UNITES STATES OF AMERICA  
NUCLEAR REGULATORY COMMISSION  
BEFORE THE ATOMIC SAFETY AND LICENSING APPEAL BOARD

TESTIMONY OF JAMES N. BRUNE

APPEAL BOARD QUESTIONS 1, 4 (PARTIAL), AND 7

DIABLO CANYON NUCLEAR POWER PLANT, UNITS 1 & 2

Figure 1.—Isoseismal map for the Imperial Valley earthquake of October 15, 1979.

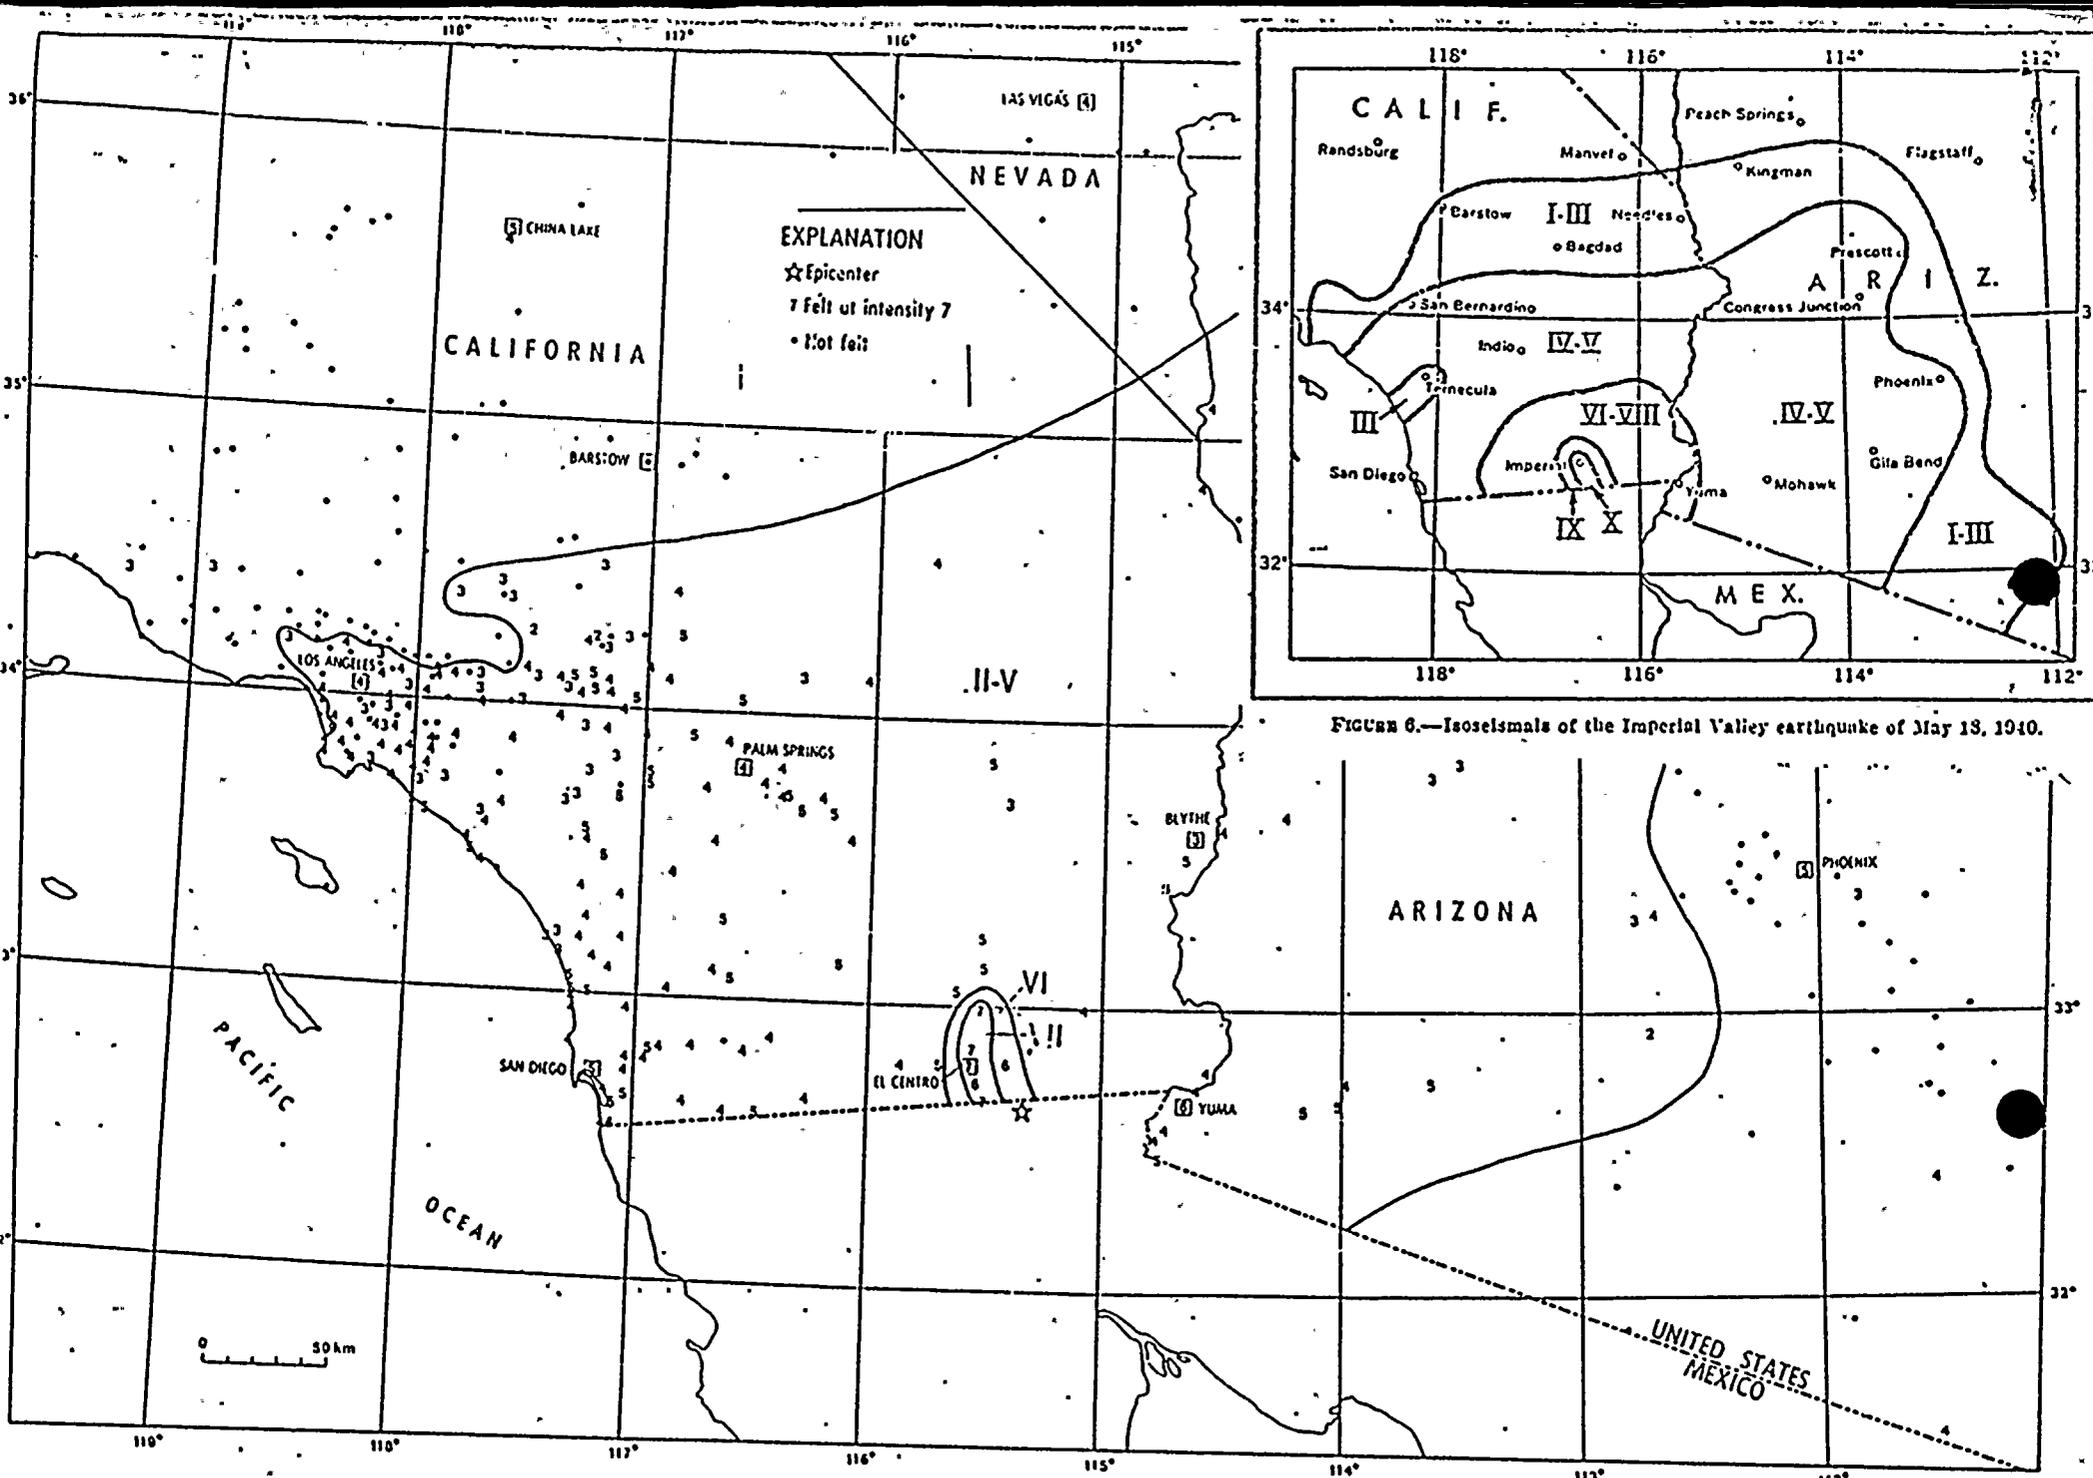
Several persons have noted that damage was relatively low for the IV-79 earthquake even though recorded accelerations were relatively high (e.g., NRC staff response). Estimates of the Modified Mercalli Intensity in the near-field for the IV-79 are less than for the IV-40 earthquake (see attached comparison, Figure 1). Although this may in part be due to ambiguities in the Modified Mercalli Intensity scale, it is

clear that the damage from the IV-79 earthquake was considerably less than for the IV-40 earthquake, even though for the IV-40 earthquake the direction of rupture was away from the region where most buildings were located. This further supports the conclusion that the IV-79 earthquake is not a conservative example for its Richter magnitude. The fault length and average slip were both larger for the IV-40 earthquake. The surface wave magnitude for IV-40 ( $7.2 \pm 1$ ) is also larger than for IV-79 (6.9) reflecting in part the larger slip in IV-40 (James Lienkamper, USGS, personal communication).
